MILITARY SPECIFICATION

TRANSMITTER, DATA: T-1257/FSS-9(V)

RECEIVER, DATA: R-1861/FSS-9(V)

This interim amendment is approved for use by U.S. Army Belvoir Research, Development, and Engineering Center with Military specification MIL-S-52877B, date 29 February 1980.

FIGURE A-1. Test fixture and test setup. X-3157C

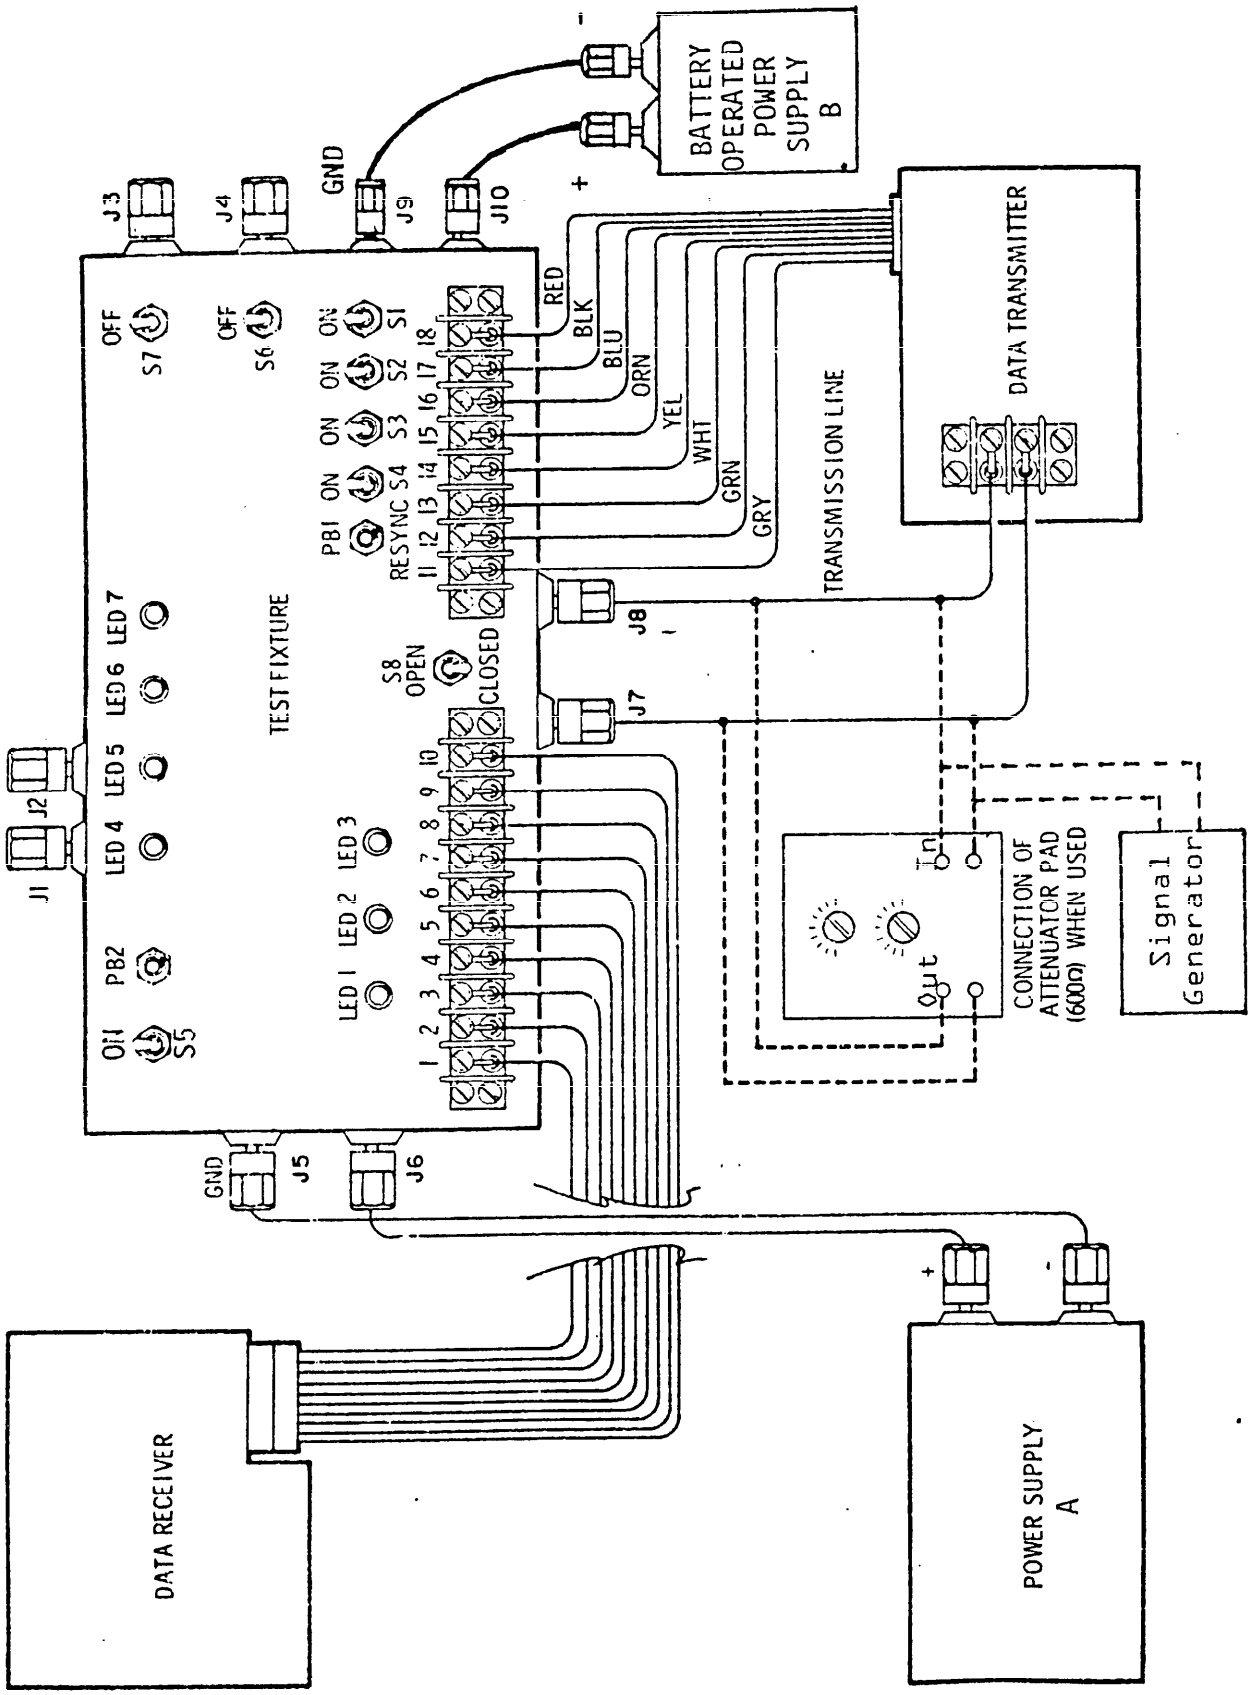
Figure A-1, delete and substitute new figure A-1.

"(d) Connect data transmitter and data receiver to the test fixture and power supplies as shown in figure A-1. Connections shown as dashed lines shall not be made at this time.

(e) On test fixture, close S8 and S5, open S6 and S7, and set S1, S2, S3, and S4 to the off position."

FIGURE A-3. Receiver demodulator test fixture no.1.

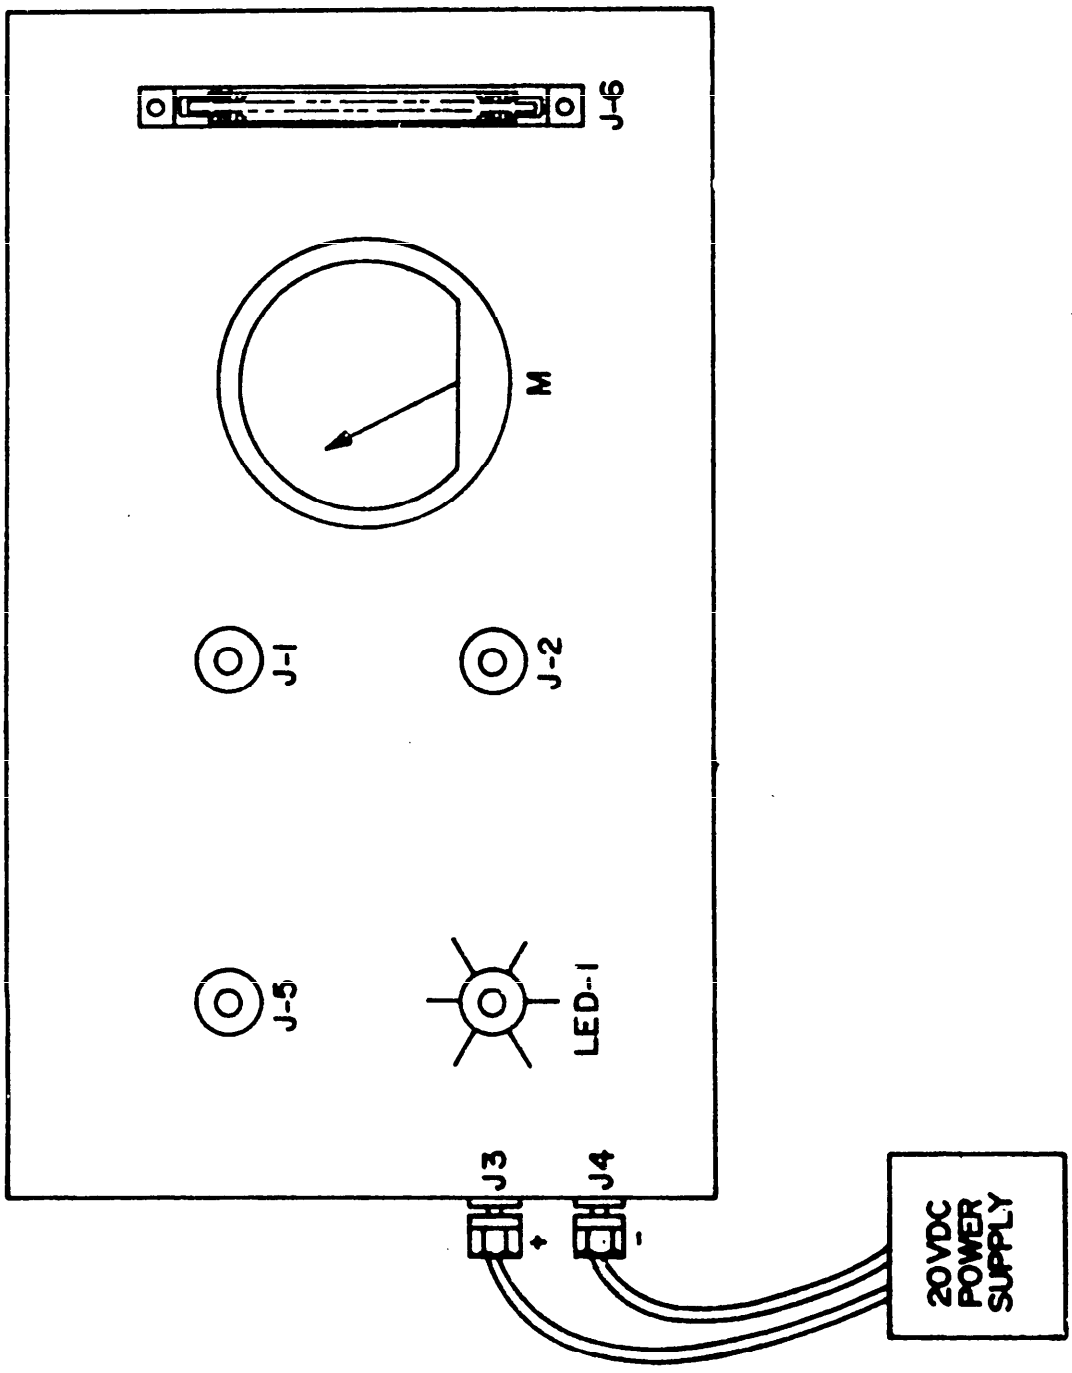
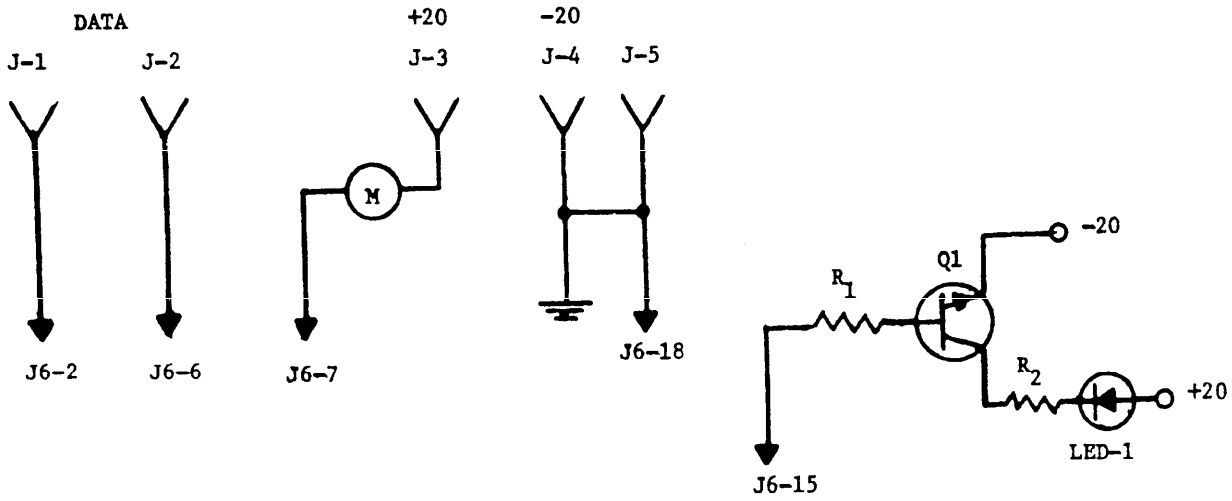
"(g) Digital multimeter - Hewlett-Packard 3435A, or equivalent.
(h) Micellaneous cables and interconnects.
(i) Test fixture No. 1 - Demodulator Receiver. (See figures A-3 and A-4).
(j) Test fixture No. 2 - Demodulator Receiver. (See figures A-6 and A-7).

(a) Connect test equipment as shown in figure A-5 using the demodulator test fixture No. 1 of figures A-3 and A-4.
(b) Adjust power supply for 20 ±0.1 Vdc. Turn power supply off.
(c) Initially select values of 182K ohms for R11 and 182K ohms for R17 on the demodulator.
(d) Insert the demodulator into the test fixture and turn power supply on.
(e) Adjust signal generator to 1170 ±5 Hz and set the output to 0 dBm. With attenuator set to 0 dB, ac voltmeter should indicate 0 dB.
(f) Connect the multimeter between TP-6 and TP-7 (gnd) of the demodulator. Voltage shall be 19.4 ±0.1 Vdc.
(g) Connect the multimeter between TP-4 and TP-7 (gnd) of the demodulator. Voltage shall be 6.8 ±0.4 Vdc.
(h) Current as indicated on meter "M" of the test fixture shall be less than 7 mA.

FIGURE A-5. Receiver demodulator test setup.

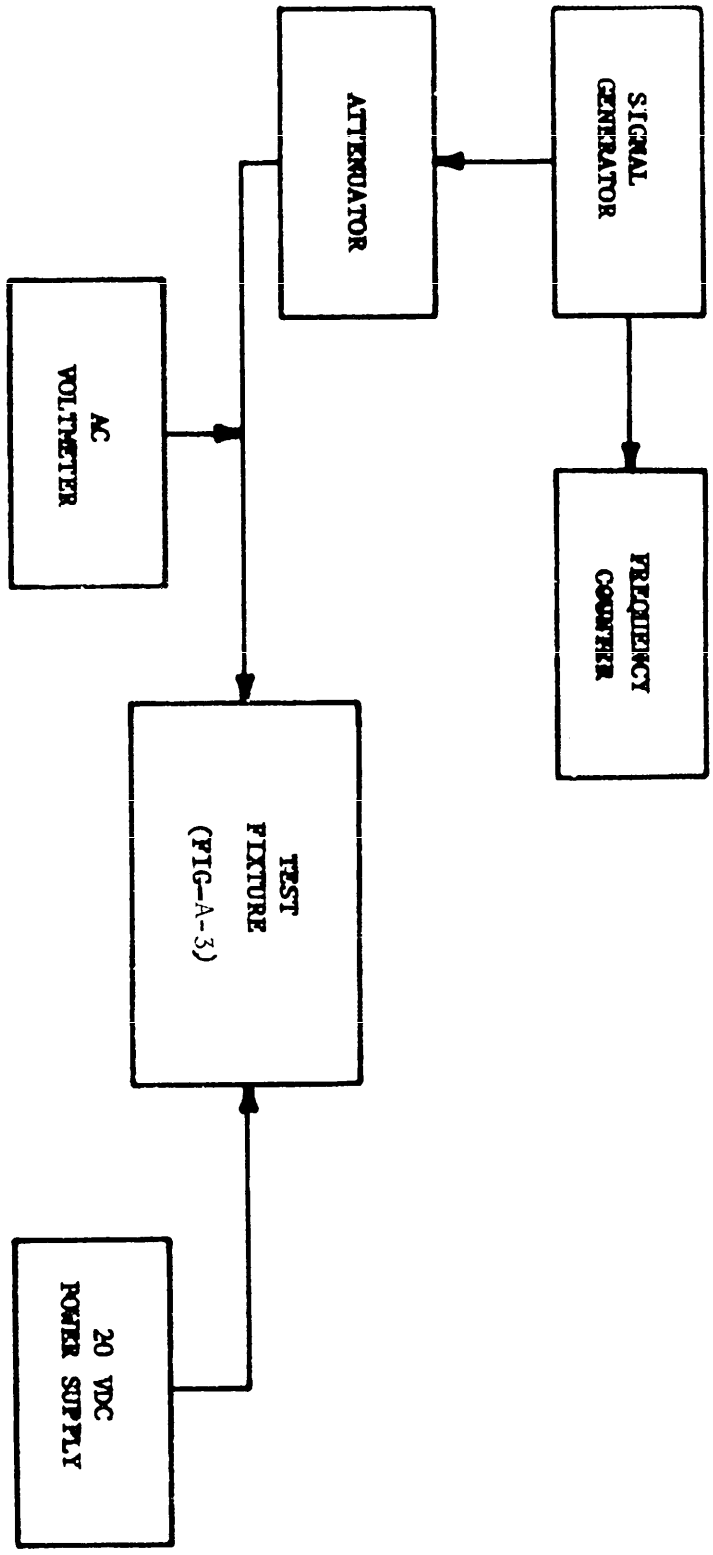
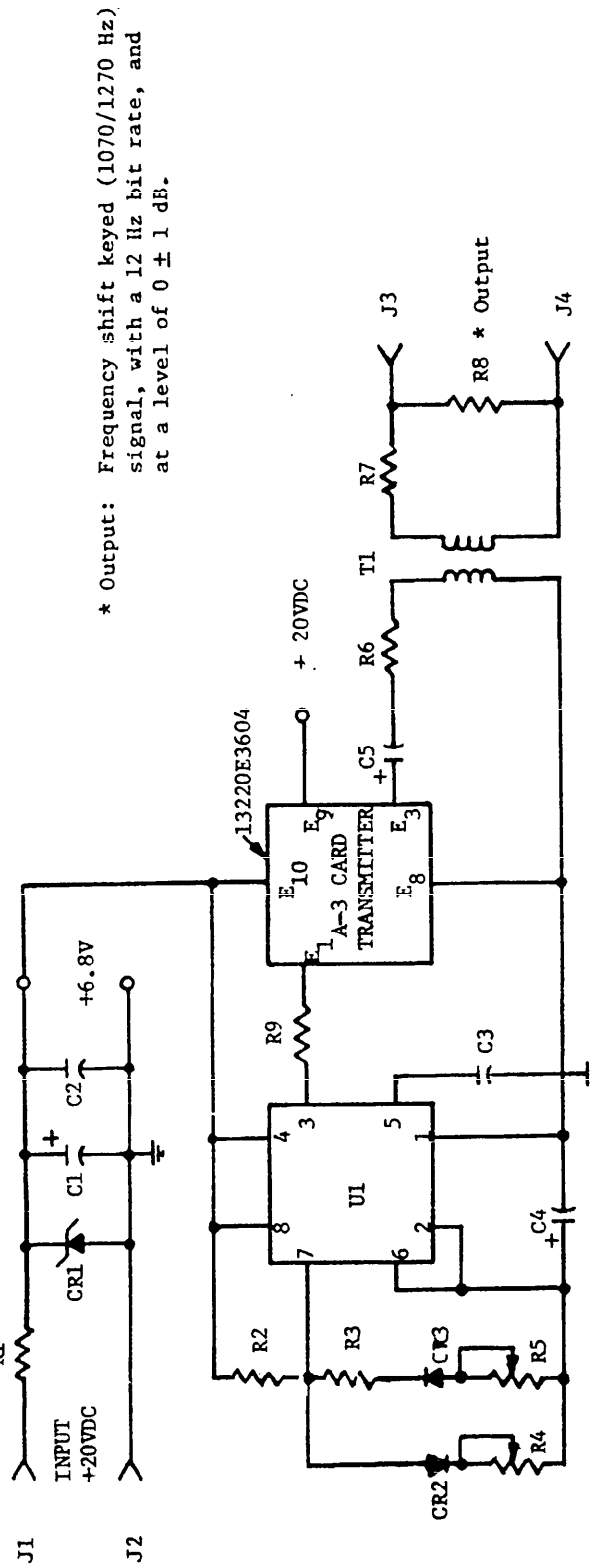
(1) Replace signal generator in figure A-5 with demodulator test fixture No. 2 of figures A6 and A7. Apply 20 ±0.1 Vdc across J1 and J2 of the fixture.
(2) Set attenuator for -28 dBm signal into the demodulator.
(3) With oscilloscope connected to TP-8 on the demodulator observe a square wave with a period of 83.3 ±1 millisecond and an amplitude of 9 ±1 V peak to peak.
